STAFF RECOMMENDATION

1503 Clayton Avenue

November 19, 2018

Application: New Construction-Outbuilding/detached accessory dwelling unit (DADU)

Figure 1: 1503 Clayton Avenue

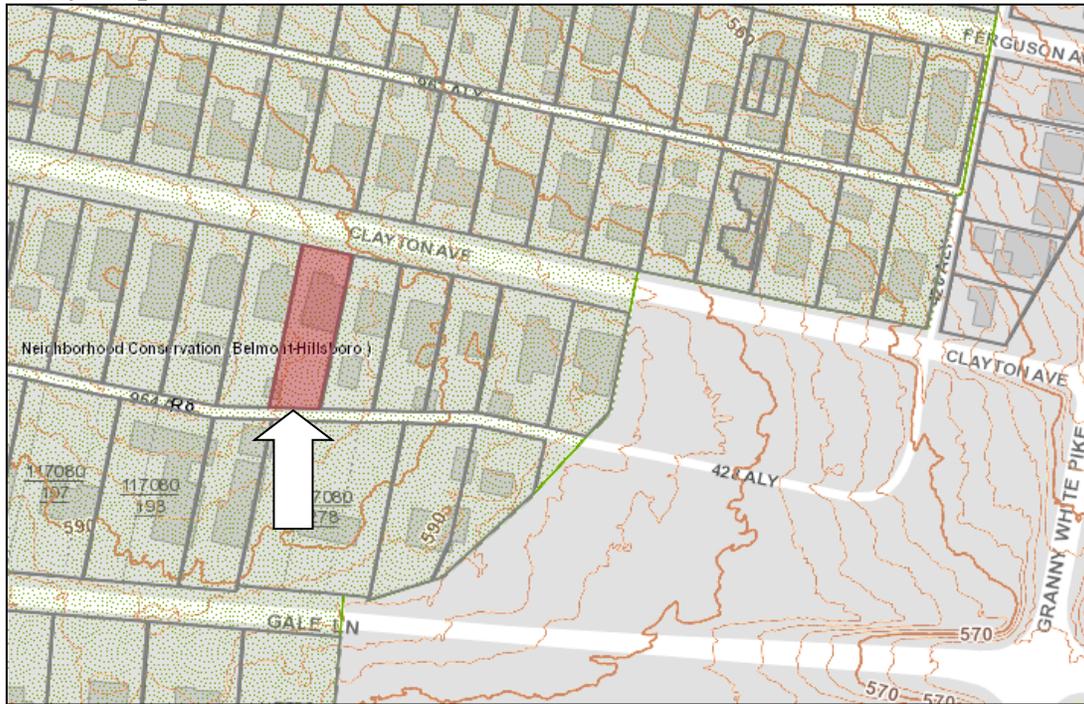
Background: The house at 1503 Clayton Avenue was constructed c. 1925 and is a contributing structure in the Belmont-Hillsboro Neighborhood Conservation Zoning Overlay.

1503 CLAYTON AVENUE
SITE PLAN

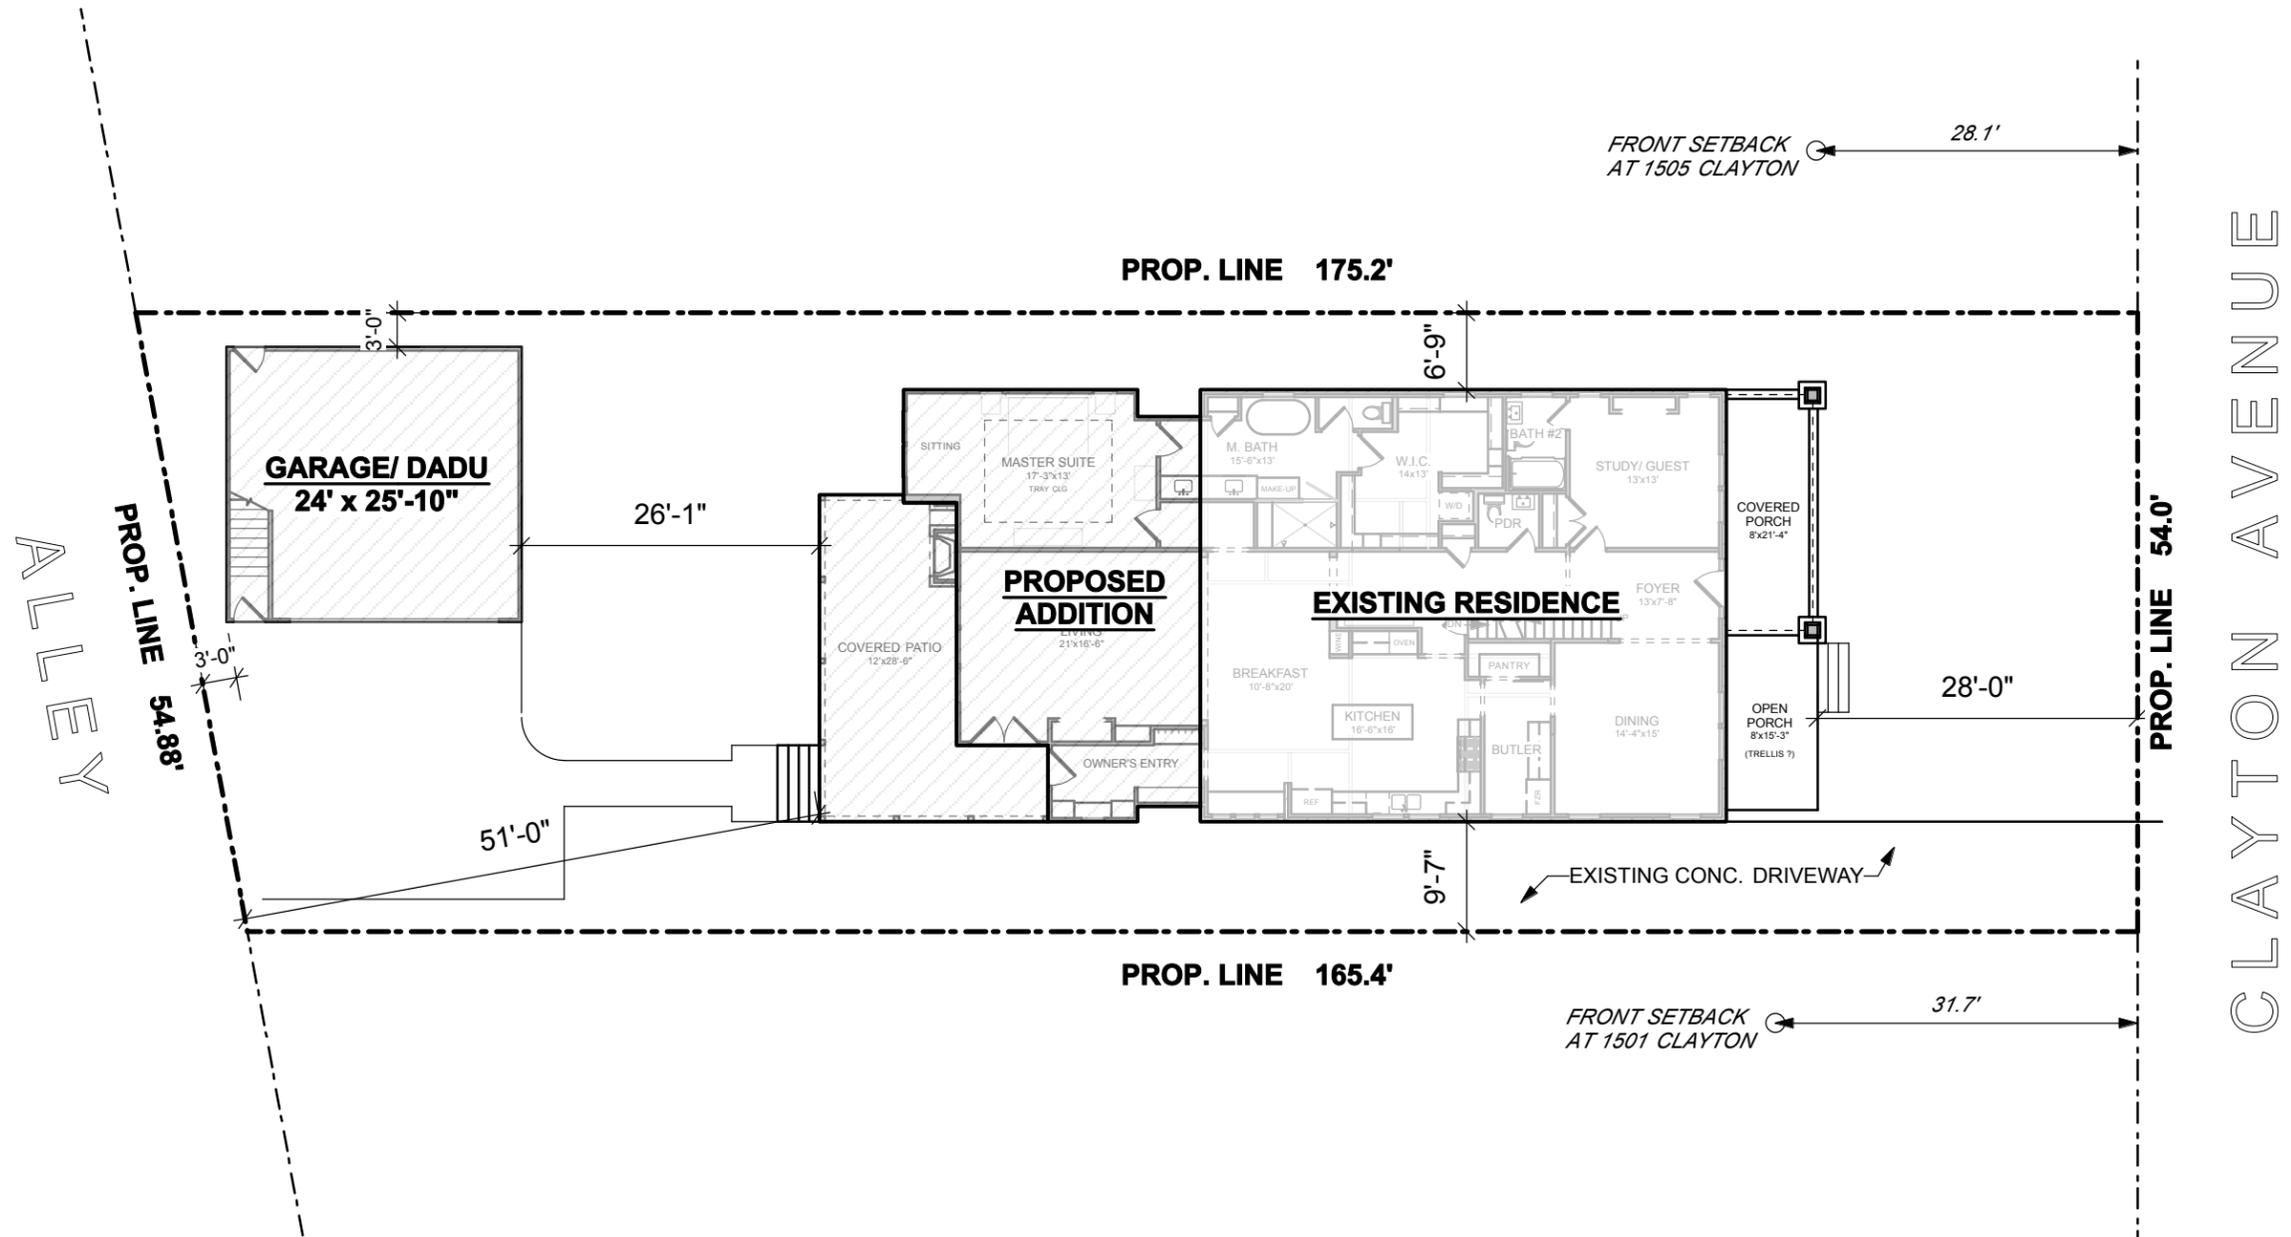
MINIMUM	PROPOSED
Building located towards rear of lot	-	Yes
Space between principal building and garage	20'	29' 5"
Rear setback	3'	3'
Left side setback	3'	3'
Right side setback	3'	27'
How is the building accessed?	-	From alley
Two different doors rather than one large door (if street facing)?	-	N/A

The project meets all base zoning setback requirements.

DADU- ALLEY ELEVATION
SCALE: 1/4"=1'

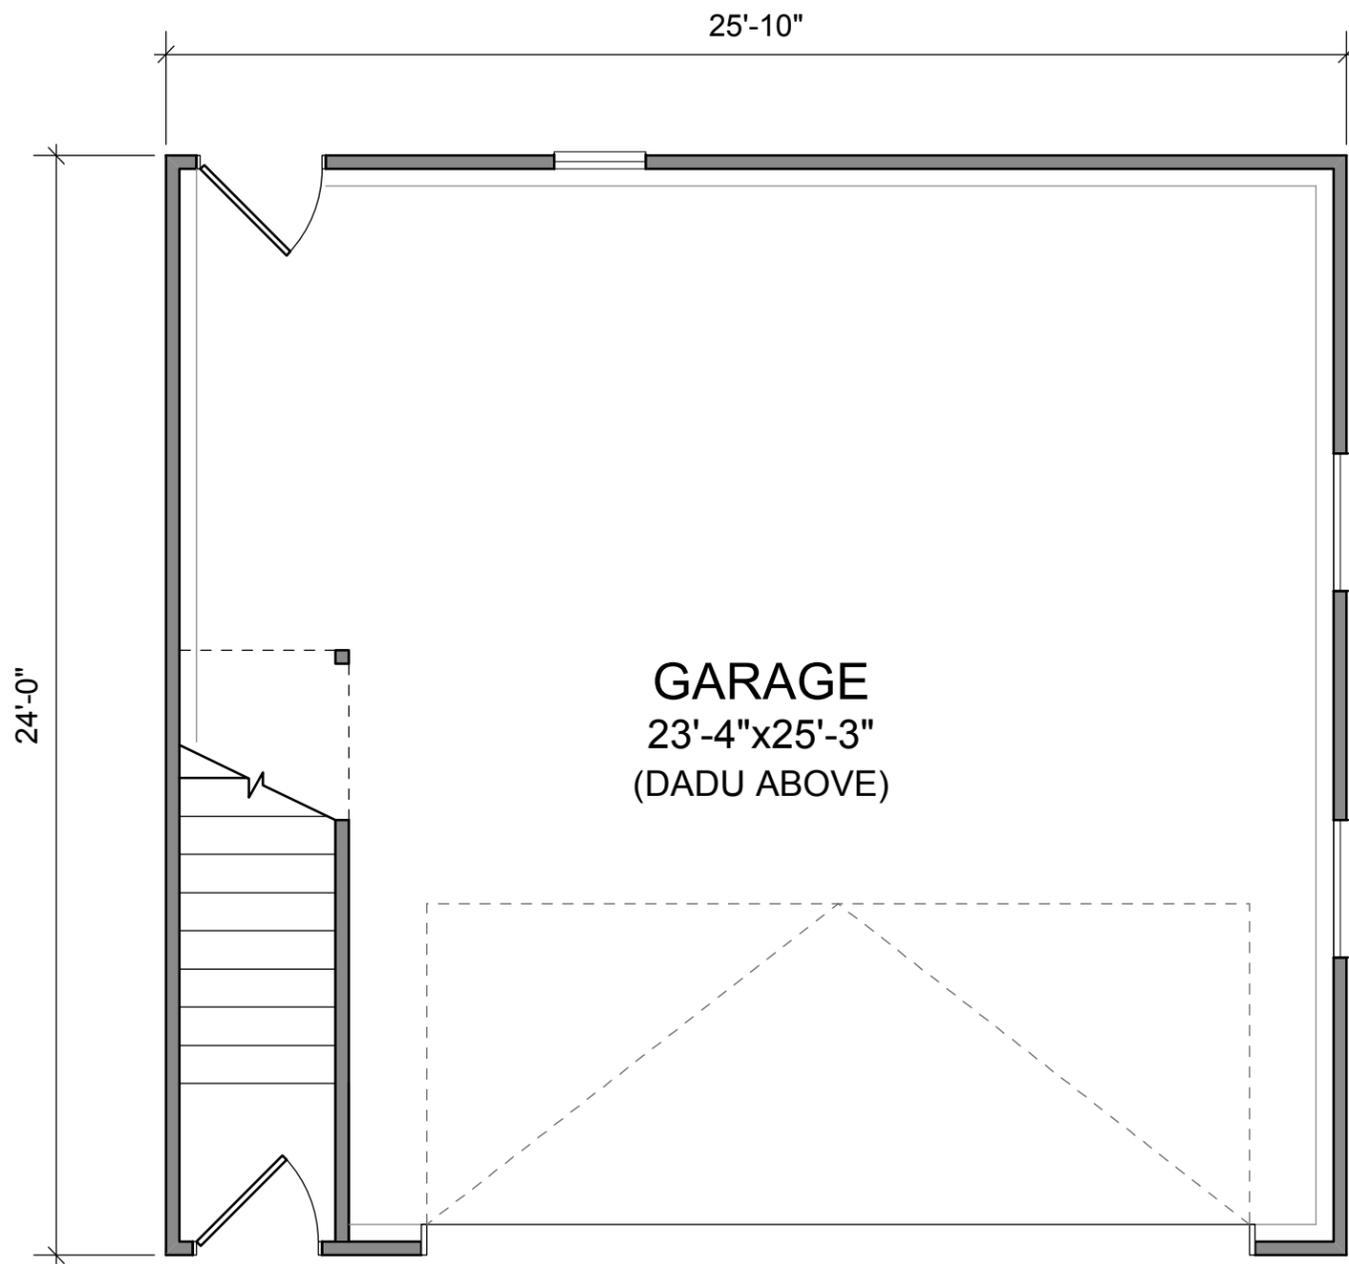
The footprint of the new DADU is six hundred and twenty-one square feet (621 sq. ft.), which is less than the maximum allowed seven hundred and fifty square feet (750 sq. ft.). The twenty-two foot (22') height and nine foot, ten inch (9' 10") eave height are subordinate to the twenty-four feet (24') height and ten foot (10') eave height of the house. Staff finds that the application meets the design guidelines Section III.B.2.h.1, and Section 17.16.030.G.7 of the DADU Ordinance for height and scale.

The proposed roof form has a gambrel roof which is not a common roof form, but is found historically and the Commission has approved in the district. The dormers meet the guidelines for width at thirty-seven percent (37%) of the roof width; however they are not set back from the wall beneath, creating the effect of a wall dormer. The Commission has required dormers to sit at least two feet back from the first floor wall; however, on a gambrel form, that is not possible. Since the proposed building itself as well as the dormers are below the maximum size allowed, staff recommends approval. The application will meet Section III.B.2.h.1 for roof shape and Section 17.16.030.G.8 for design standards of the DADU Ordinance.

No materials are indicated on the submittal. For the materials to meet Section II.B.1.d, staff recommends final approval of all proposed materials prior to purchase and construction.

1. Staff shall review and approve all materials prior to purchase and installation.
